City of Tualatin

ARCHITECTURAL REVIEW FINDINGS AND DECISION

**** APPROVAL WITH CONDITIONS ****

Case #: AR-18-0001
Project: TVF&R Station 39
Location: Adjacent to 7100 SW McEwan Road
(Tax Lot: 2S113DD01601)
Applicant: Frank Angelo, 921 SW Washington Street, Suite 468, Portland, OR 97205
Project Contact: Same

SITE PLAN

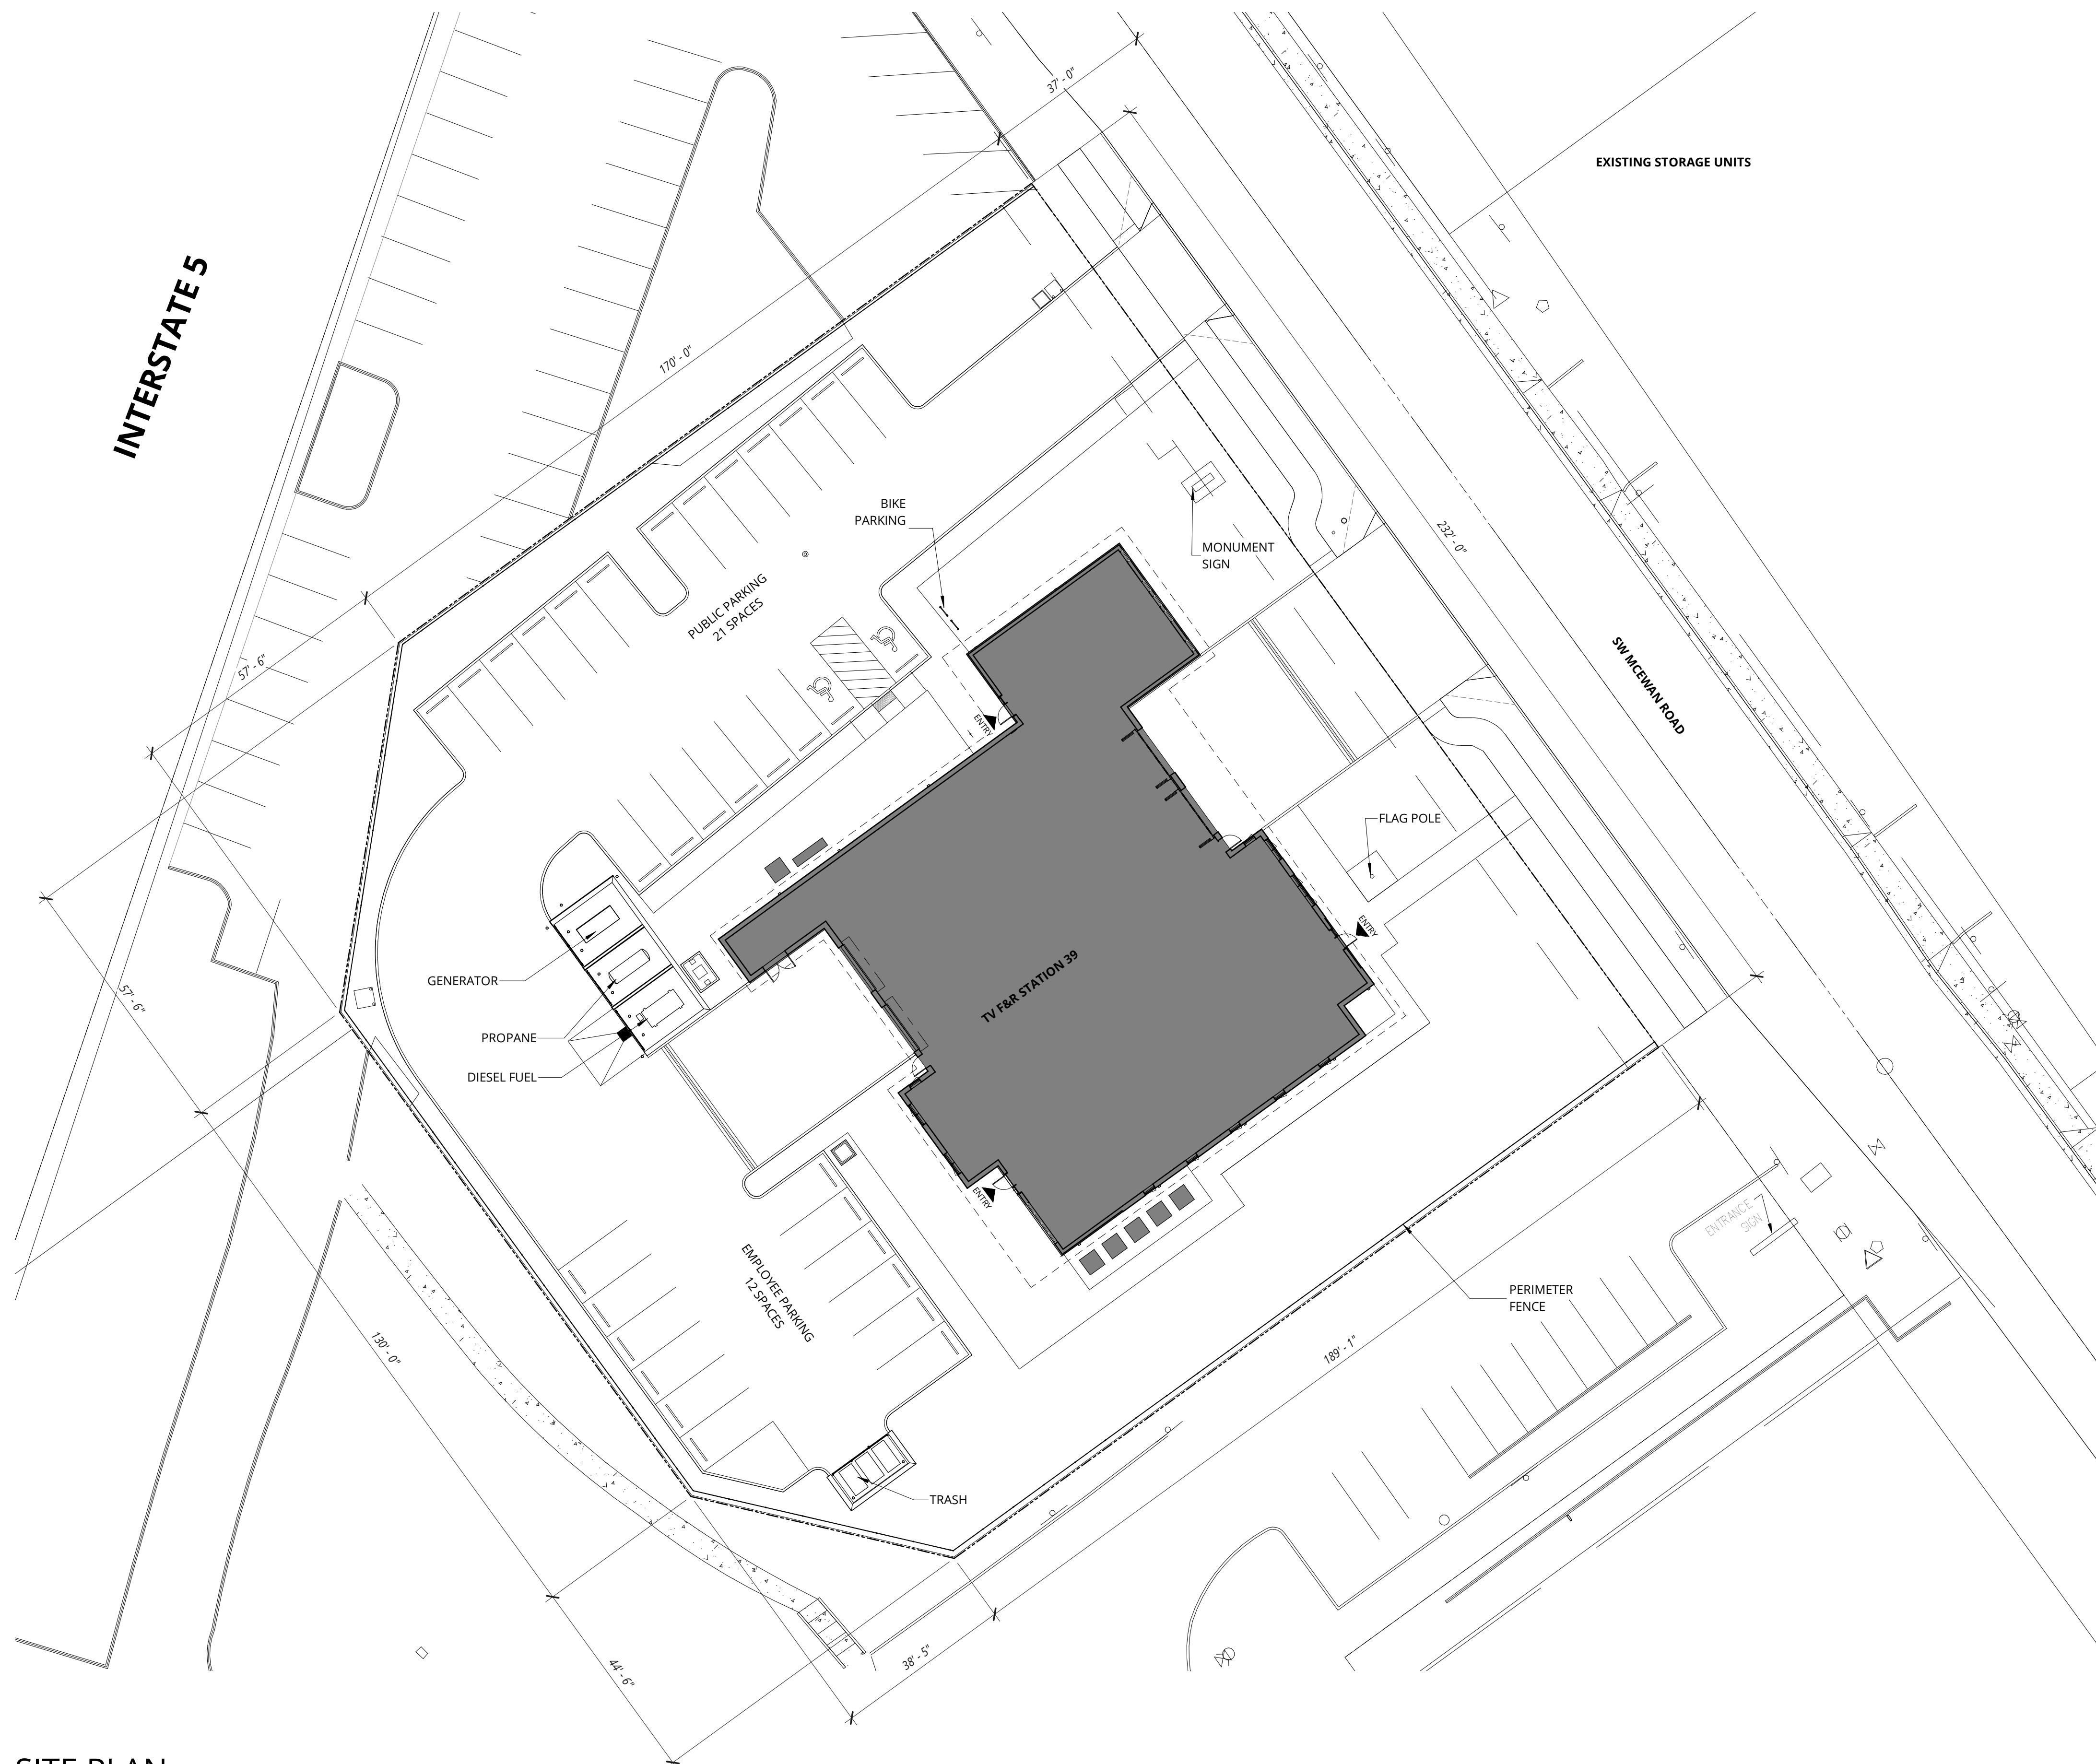
Sheet 1, Site Plan, illustrates that parking stalls are 9 x 20 ft and two way access aisles are 24 ft wide at narrowest point. Figure 73-1 requires a stall depth of 18.5 ft for 90 degree parking. This standard is met.
